PA Reg Ref: 2443414 Case Type: Appeal - LRD Lodgement Type: Appeal - LRD

Planning Appeal Report

Third Party planning appeal in respect of the decision of Cork City Council, made under planning application, reg. ref. 2443414, to issue Notification of Intention to Grant Planning Permission for inter alia: "Permission for the following Large Scale Residential Development (LRD) comprising the demolition/removal of existing ruins/structures including a former dwelling on the northern part of the site) and the construction of 550 no. residential units to include 394 no. dwelling houses (comprising a mix of 2 3 and 4 bed semi-detached and townhouse/ terraced units) and 156 no. apartment/duplex units (comprising a mix of 1 and 2 bed units in 10 no. blocks ranging in height from 2 to 6 storeys) 1 no. creche 3 no. commercial units (comprising a shop café and medical/general practice facility) and all associated ancillary development works ... all other ancillary development located to the north of Dunkettle House (protected structure - PS1190) and associated structures (protected structures - PS1238 PS1239 PS1240 PS1170) Dunkettle (townland) Glanmire Cork ..."

Fig. 8. Proposed site layout plan proposed to adjoin client property (Source: CCCPlanning File)

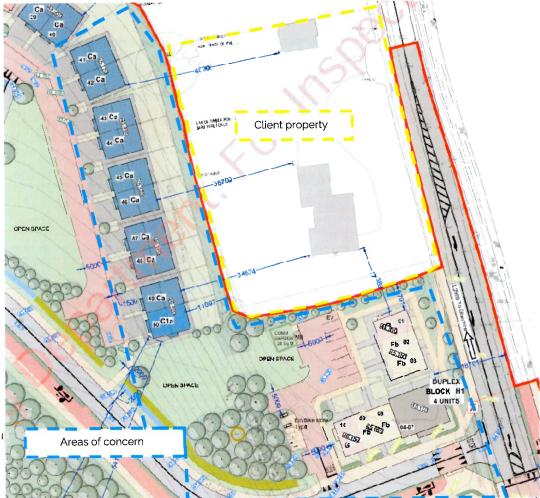
We note that the applicant drawings show a significant tree and vegetation buffer only on our client's side the shared boundary. The applicant scheme will remove all existing trees and vegetation this from their side of the boundary to facilitate the proposed development, while our client is under no obligation to retain any boundary planting, etc. The applicant drawings are misleading in this respect – see Fig. 19. Fig. 19 essentially shows our client retaining a significant tree buffer to the west side of her property. This is not accurate, nor can our client be required to retain any vegetation or trees within her property. Further, if her property is redeveloped in the future, there is no possibility such trees and vegetation would arise.

The submitted landscape plan is silent on how planting on or adjoining the party boundary with our client's property is to be undertaken (if at all).

The applicant does not provide any boundary proposals as regards the party boundary with our client's property on its two impacted sides.

Fig. 11: The ground level of Dwelling Types Ca set out in Section B-B (Source: CCC Planning File)

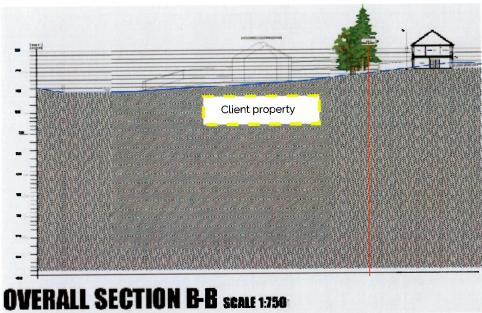
placed nine houses (Type Ca and Cl a, nos. 42 to 50) on top of the entirety of this boundary (see Section 5.1 of this Planning Appeal Report). These units would tower above our client's property causing overshadowing, including blocking daylight and the skyline. The proposals would remove all views of the rural landscape which has always surrounded the property. The proposed dwellings would cause adverse overlooking the rear of her home on its western side and as well as the garden's northern aspect. The proximity of the rear gardens of these units (which are just 8m in length) to her boundary is evident in Engineer's Drawing 3442-JODA-01-00-DR-C-1000 and in Section 5.1 of this Planning Appeal Report.

- Require the applicant to submit amended plans which effectively reinstate the original plans for the areas of the site adjoining our client's property, as per the previous planning application/appeal.
- Relocate house Nos. 42 to 50 to the green areas west of this row of houses (See Architect's Drawing Schedule of Units Part V) and to designate their current location as a green area for the benefit of the new residents and established residences. Our client considers that there is no possible justification for placing house Nos. 42 to 50 in their current location.
- The proposed dwellings should be dormer in design to avoid first floor windows facing Broomhill.

Fig. 15: Proposed cut and fill close to client's boundaries (Source: CCC Planning File)

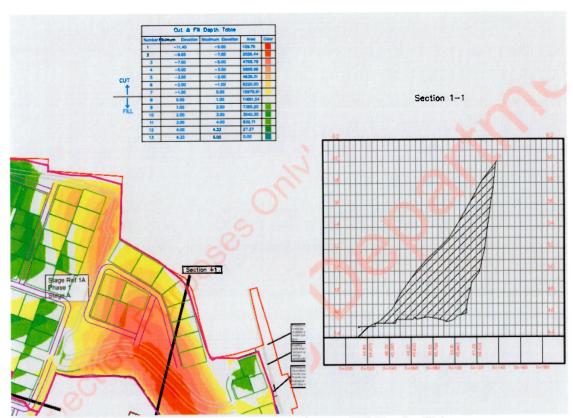
Our client is very concerned over the extent of proposed cut and fill works to take place on the site. Chapter 9 of the EIAR sets out the scale of these proposals but it does not adequately assess their likely impact on the area. Indeed, the entire EIAR appears to accept without much question that vast cut and fill works and exports of soil and sub-soil are standard. This extent of cut and fill is not standard. The topography of the site is so sloping that it cannot be developed without these works and retaining structures being built across the site. These works are not justified by the EIAR including their impact on our client's property which would be impacted by noise, dust, HGV traffic, etc.

Other sections of this Planning Appeal Report address noise, vibration, and dust concerns arising from this scheme. Our client does not accept that it is reasonable to site a car park up to her boundary and to carry out all of the associated scheme works such as cut and fill and retaining structure development right up to her boundary.

Fig. 19: Applicant drawing – Section B-B - showing trees and vegetation only on client's side of the shared boundary (Source: CCC Planning File)

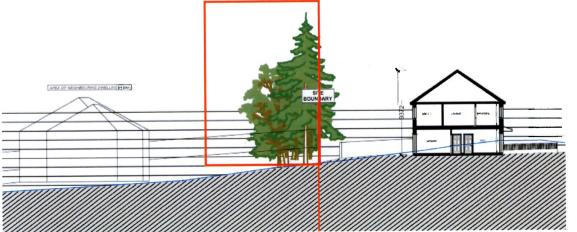
We note that the applicant drawings show a significant tree and vegetation buffer only on our client's side the shared boundary. The applicant scheme will remove all existing trees and vegetation this from their side of the boundary to facilitate the proposed development, while our client is under no obligation to retain any boundary planting, etc. The applicant drawings are misleading in this respect – see Fig. 19. Fig. 19 essentially shows our client retaining a significant tree buffer to the west side of her property. This is not accurate, nor can our client be required to retain any vegetation or trees within her property. Further, if her property is redeveloped in the future, there is no possibility such trees and vegetation would arise.

BPS is unable to find any existing or proposed boundary treatment drawings showing the existing or proposed interface between our client's property and the subject site. This appears to have been overlooked, or the details are not available online. CCC appears not to have considered, at all, the need for the applicant and our client to agree a common boundary. Our client has requested a solid stone faced and topped wall to act as a visual barrier and an acoustic barrier.

Lower Left – Old stone wall abutting Broomhill.

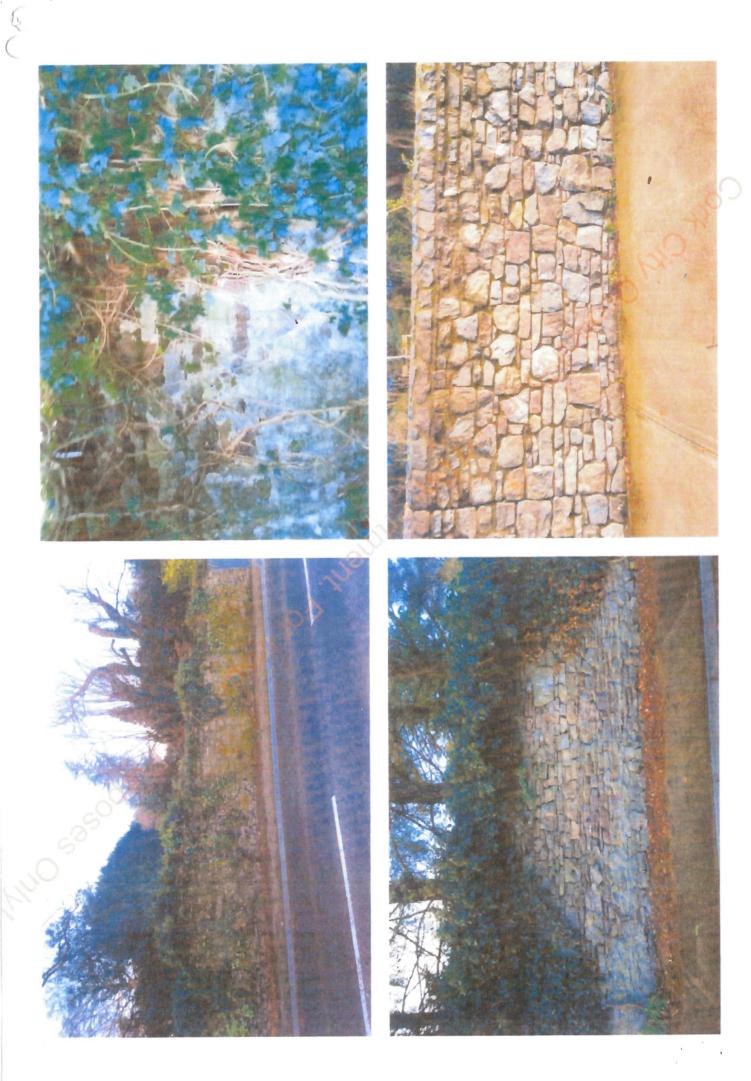
Require the applicant to provide a solid wall between the scheme and our client's property. In our client's words: "It is imperative that a solid screening wall of 2.5 metres minimum height should be erected on the common party boundary". In order to align with the existing historical setting and surroundings of her home and the Dunkettle lands upon which the proposed development is to be builtand to preserve its character, the said wall should be of stone finish. CCC has itself acknowledged the character of this area by recently erecting stone finished walls along the Dunkettle Road directly opposite Broomhill and beyond. Appendix 1 of this Planning Appeal Report includes photographs by way of illustration:
